Re: Safari Highlands Ranch DEIR Analysis

The attached is an analysis of the Safari Highlands Ranch Aesthetics and Visual Resources Section of the Draft Environmental Impact Report (DEIR).

Figure 6: SENSITIVE AREAS

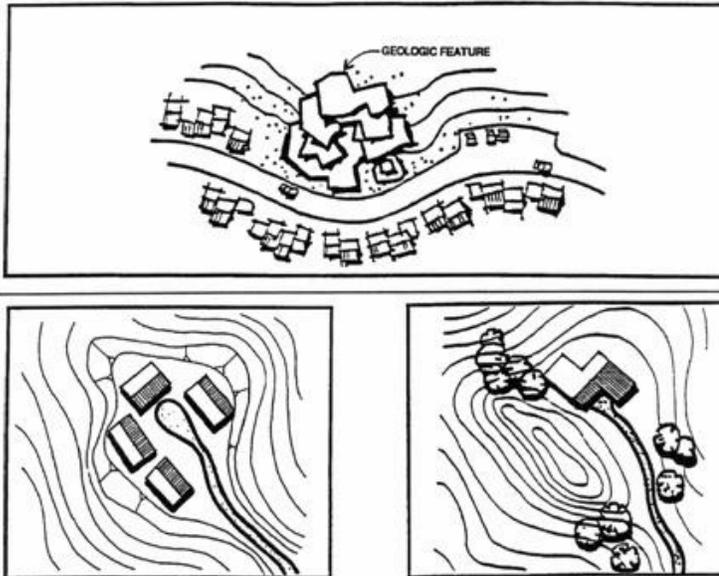
Furthermore, in accordance with **Sec. 33-1067.F. Design guidelines for HRO district**, Grading should be limited to the extent possible and designed to retain the shape of the natural landform (see figure 6 above).

Padded building sites are allowed, but site design and architecture techniques (such as custom foundations, split level designs, stacking and clustering) should be used to mitigate the need for large padded building areas. Grading must be designed to preserve natural features such as knolls or ridgelines. ***In no case should the top of a prominent hilltop, knoll, or ridge be graded to create a large building pad. Again, the Project does appear to grade the tops of prominent hilltops, knolls, and ridges to create large building pads.***

Figure I
Viewpoint Locations
Safari Highlands

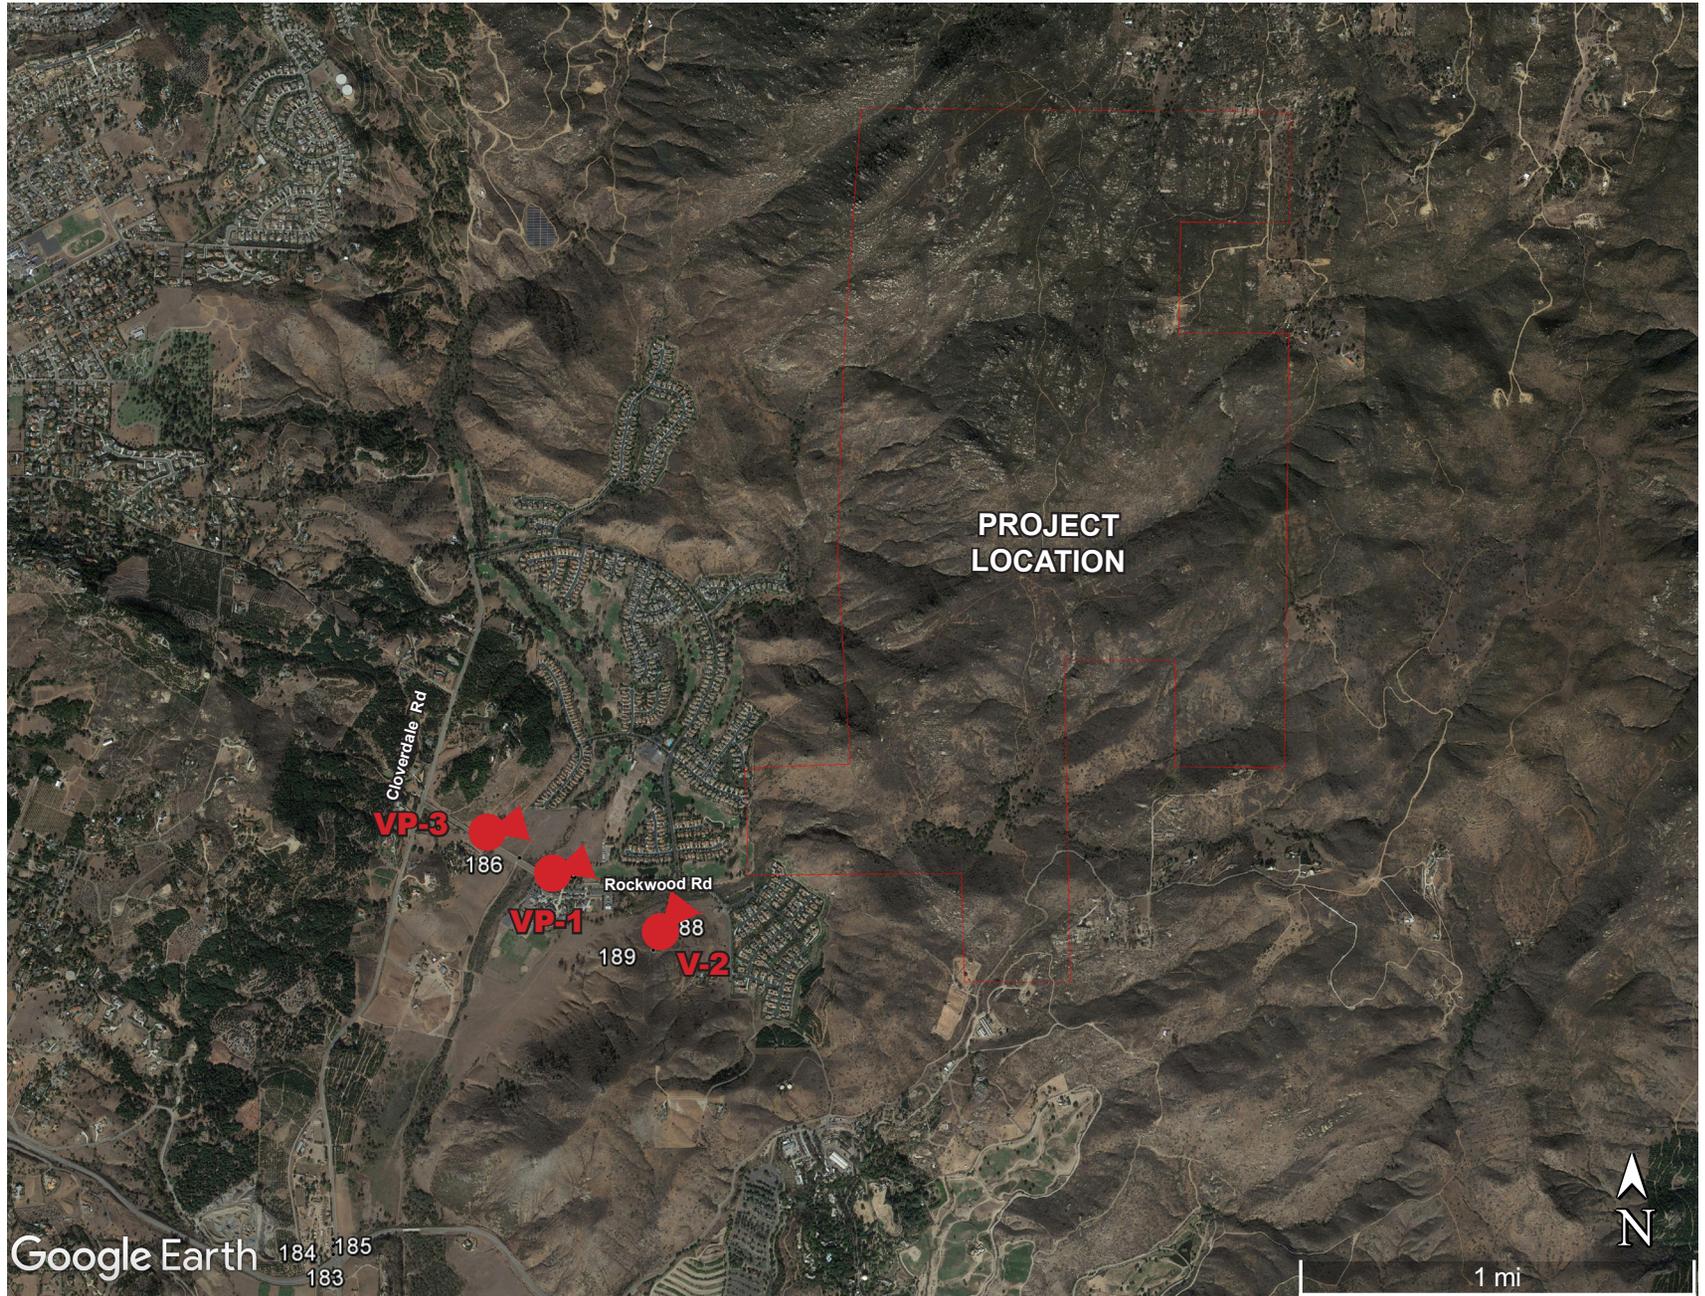
Intermediate ridgelines traverse the Project site, running generally from the southwest to the northeast (see Figures). As depicted in the simulations provided in the DEIR and on the figures that follow, intermediate ridgelines, and sensitive hillsides are anticipated to be impacted by project implementation. The Project does not appear to subordinate to the natural landforms but projects above them, nor does it minimize the visual impact of grading.

The Project proposed will be located on and near protected hilltops and ridgelines that define the backdrop of the San Pasqual Valley (see Figures). These resources are prominent, memorable, and largely intact as viewed from the key views discussed in the DEIR and those recommended for further study. The Project as proposed will result in the grading of large flat pads above hilltops and ridgelines and the construction of large man-made cut and fill slopes, some more than 130’ in height. This will occur in conjunction with the removal of native vegetation and boulder outcroppings. In addition, thinning and removal of additional native vegetation will be required for brush management. These landform and resource alterations will be further exacerbated by proposed ridgeline/hilltop development visible

Figure 2

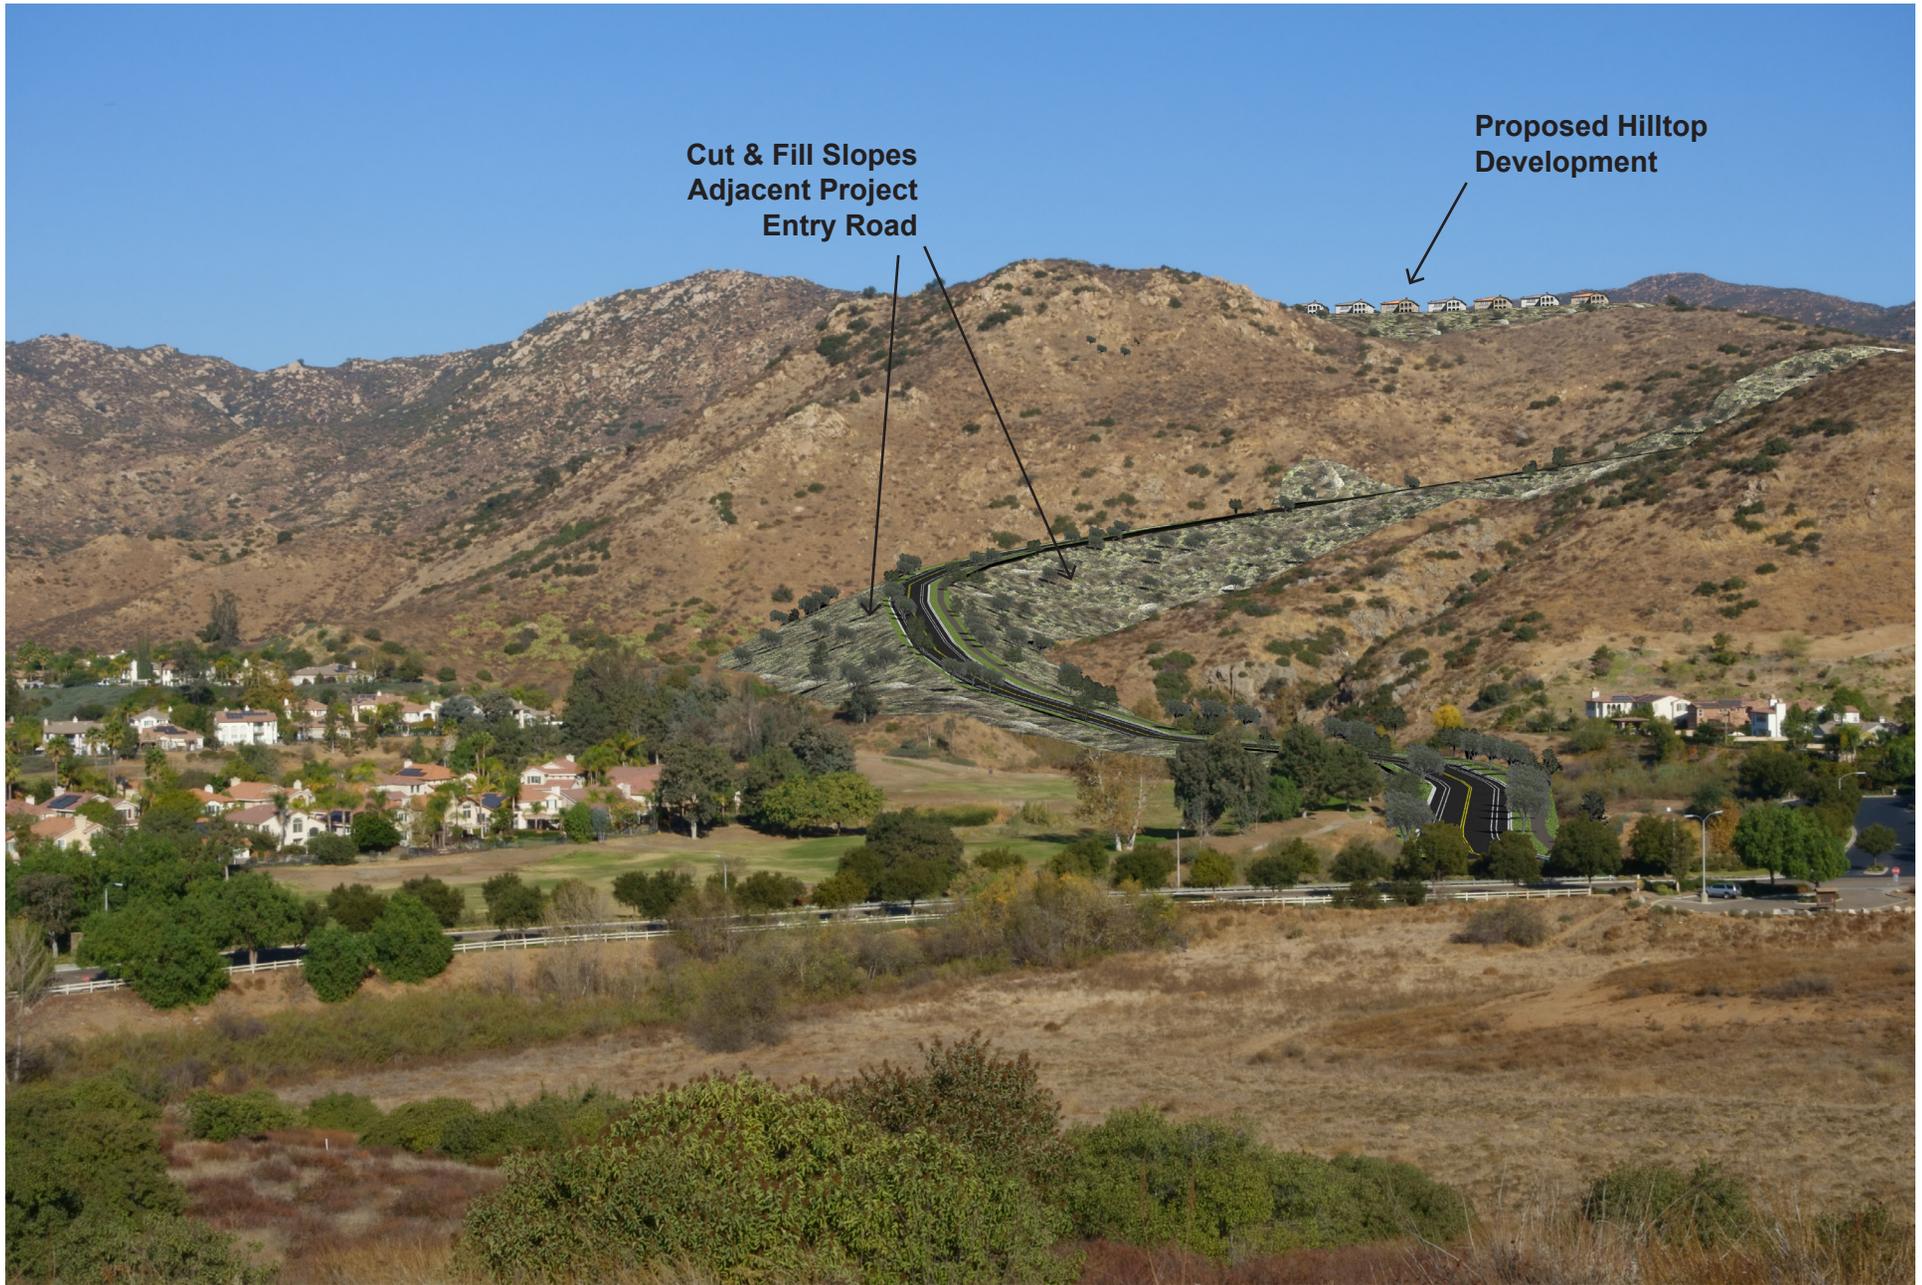
The **Eagle Crest LCU** represents the nearby residential and the recreational receptors associated with the golf course and the San Pasqual Union School (KOPs 19 and 20). It appears that trail users along Rockwood Rd. and Cloverdale Rd. are perhaps under represented. Views from these trail areas appear to encompass large manufactured slopes and hilltop homes backed by sky (see Figures). It is anticipated that views toward the ridgeline from these locations will be diminished by disruptions in the continuity of the landforms caused by these improvements.

Specific Plan level measures related to architecture, engineering, and landscape architecture, are proposed, along with large areas of on-site open space, to reduce impacts associated with the Project however significant impacts to visual resources will remain. The visibility of improvements will continue to contrast to a large degree with the existing native hillsides and natural landforms surrounding the Project. These otherwise intact natural hillsides and ridgelines will be disturbed and impacted with man-made improvements, verdant irrigated slopes, and hilltop homes backed by sky, in conflict with City policies adopted to protect them. **It is anticipated therefore that changes, as a result of project implementation, will be adverse and significant, and will alter public views of the site and/or affect scenic vistas (see Figures 1-7).**

Figure 6

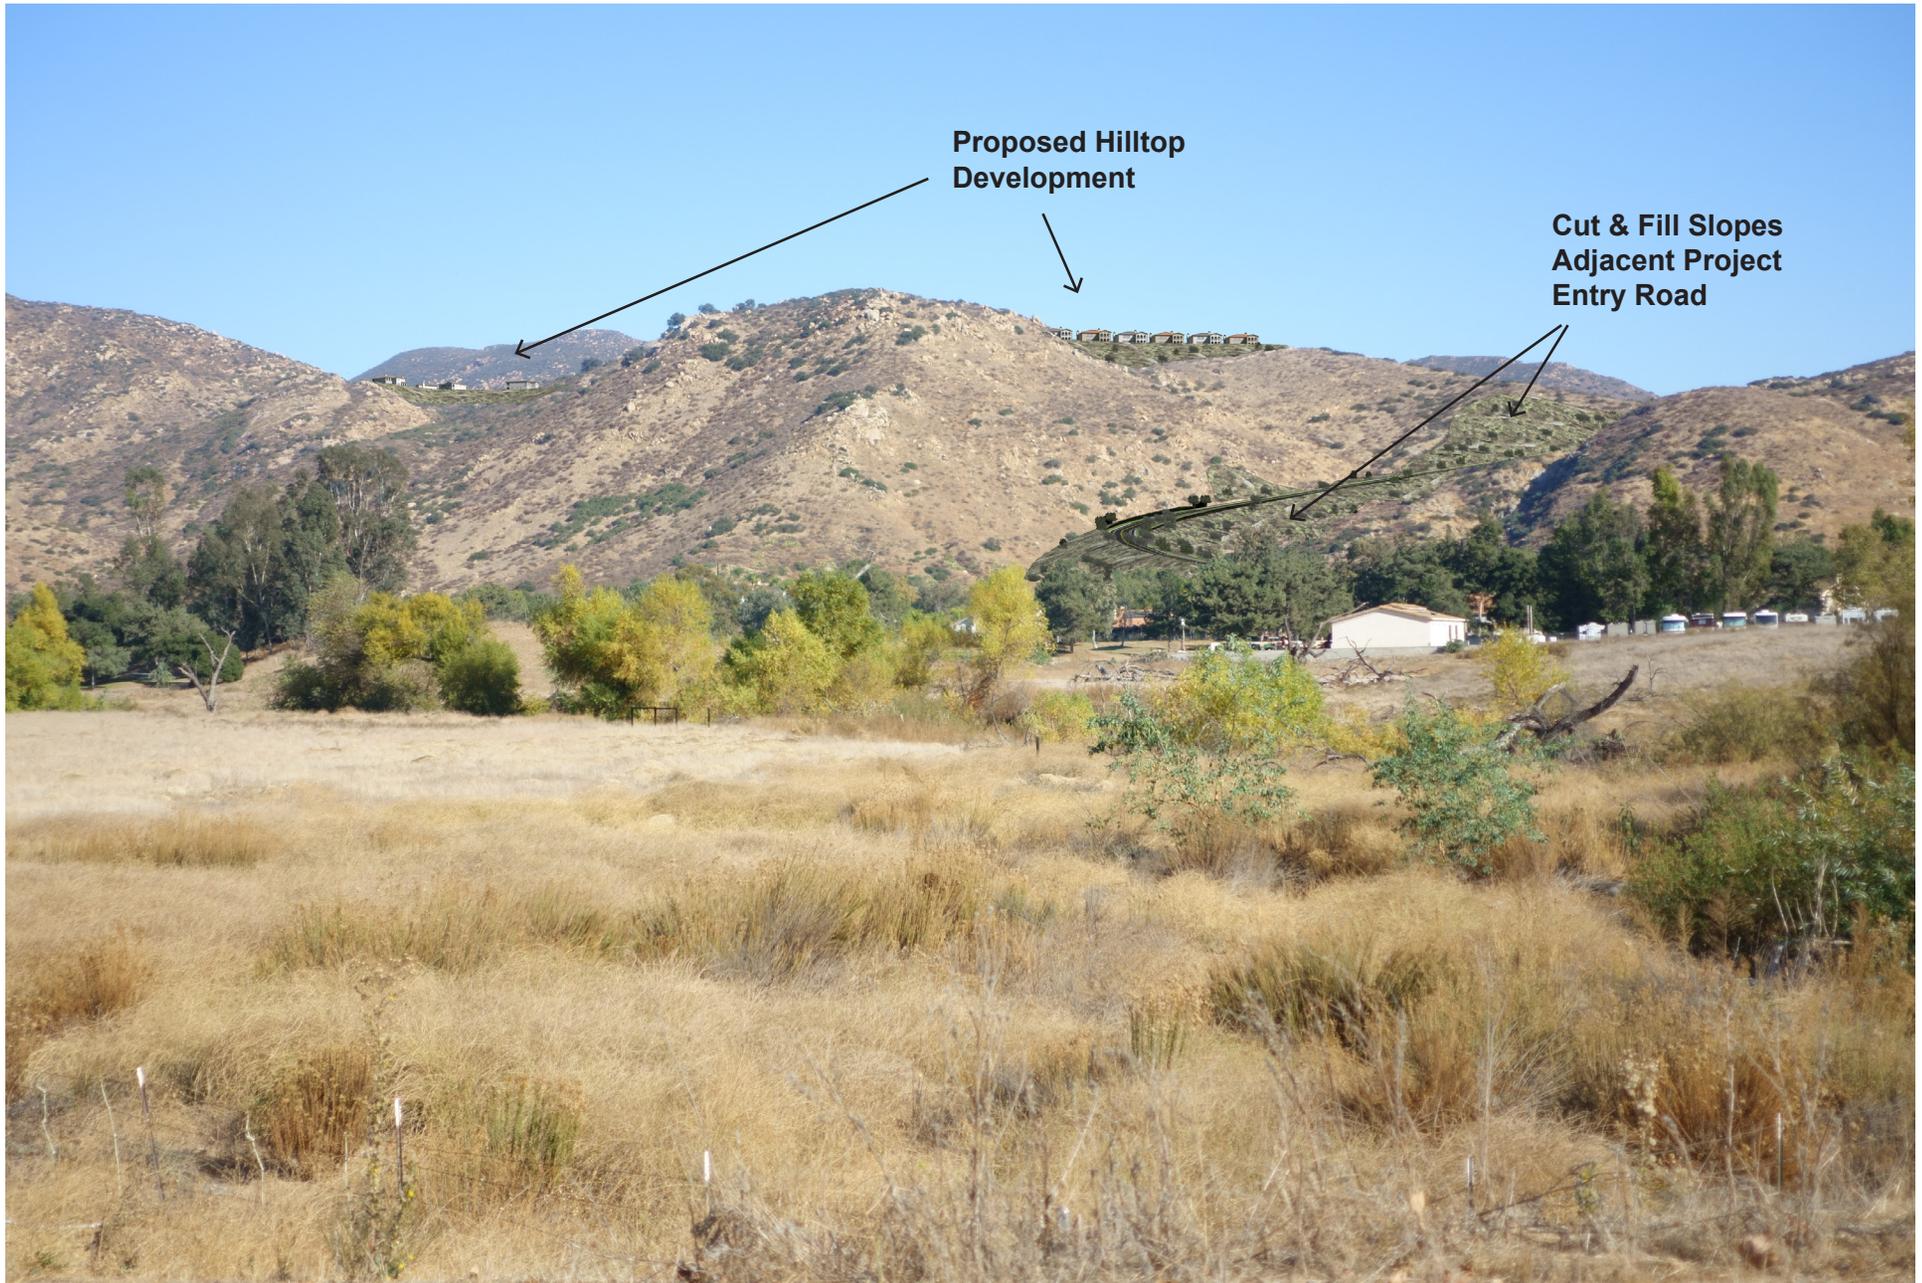
them. **It is anticipated therefore that changes, as a result of project implementation, will alter public views of the site and substantially damage scenic resources, including, but not limited to, trees, rock outcroppings affect scenic vistas (see Figures 1-7)..**

Specific Plan level measures related to architecture, engineering, and landscape architecture, are proposed, along with large areas of on-site open space, to reduce impacts associated with the Project however significant impacts to visual resources will remain. The visibility of improvements will continue to contrast to a large degree with the existing native hillsides and natural landforms surrounding the Project. These otherwise intact natural hillsides and ridgelines will be disturbed and impacted with man-made improvements, verdant irrigated slopes, and hilltop homes backed by sky, in conflict with City policies adopted to protect them. **It is anticipated therefore that changes, as a result of project implementation, will alter public views of the site and substantially degrade the visual character and quality of the site and its surroundings (see Figures 1-7).**
